ILC Dump Issues That May Need Further Work or Study

R. Arnold
SLAC

This is a second pass at a list of some issues in the design and performance of the ILC dumps as presented in the RDR and supporting documents that may need further work in analysis, experimental tests, engineering or prototyping in the EDR phase of the project. This is the starting point for discussion for a tally of work-to-be-done, with the help of all in the ILC Dump team, by work packages in the EDR phase aimed at reducing cost or technical risk. We have clear instructions from the Project Managers at the BDS KOM to take a sharp look at all aspects of the systems to find ways to make them cheaper and/or more robust. Some of the questions here may reflect my poor understanding of the issues, and the answers to some concerns outlined here may be obvious or already answered somewhere previously that I am not aware of. Some of the issues noted here are in the line of straight-forward design problems that require work by engineers and designers and do not require high priority R&D in the EDR phase to eliminate risks, but are listed here for the complete picture. Also some of the issues will be covered by work in o

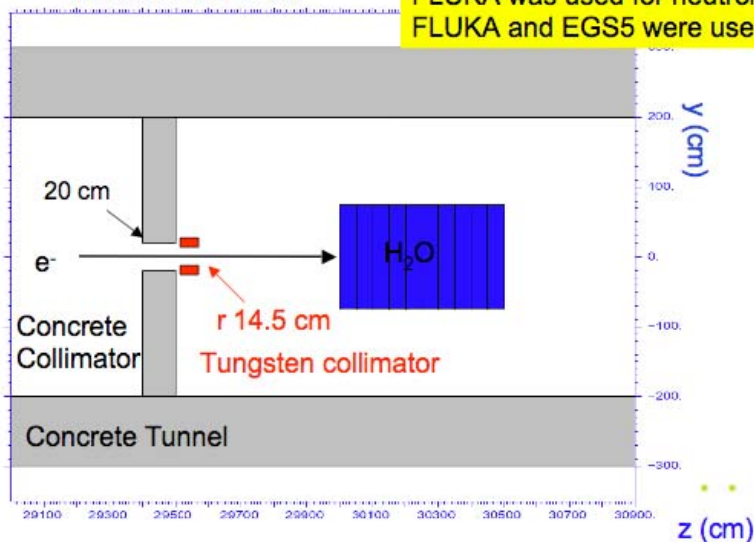
- Power level required: What power level (instantaneous and average) are these collimators required to handle? Simulations show wide range in average power lost on the collimators depending on beam power, beam offsets, and alignment at the IP (see Yury's talk at LCWS07). Beam disruption will be modulated by the tuning with the feed back system for the first few hundred bunches as the beams are brought into collision. During that period there will be wild variations in instantaneous power on the collimators due to disruption and spray generated by beam offsets. The collimators need to be able to handle the expected levels of instantaneous power for short time periods. Yury and Lew both mentioned in various presentations that the Beam Delivery System needs to detect and efficiently prevent sustained operation (more than a few seconds?) with large beam offsets to prevent excessive power loss on the collimators. If the average power is never more than 40 kW then peripherally cooled metal will do, assuming they can handle the possibly larger instantaneous power for short bursts. If the average power is ever expected to be larger than 40 kW (after the upgrade to 1 TV cm energy), then the dump design may need to be water based (water cooled metal balls). [Note: Dieter designed and built 100 kW capacity edge cooled dumps of 1.45 m Al followed by 10 X_0 steel absorbers for the main dumps in the SLC extraction lines that could be a model for the doughnut collimators.] A peripherally cooled dump can be designed so that very little hydrogen and oxygen is evolved in the water so recombiners are not required, and tritium production is much less than in direct water cooled version. That reduces the complexity and cost of the water systems and reduces the risks. The water systems could probably be completely independent of the radioactive water systems of the main dumps. A peripherally-cooled metal dump would permit a cleaner solution to designing a sharp aperture covering the doughnut shape without compromising water flow or having issues with the material thickness at the inner edges (container walls).
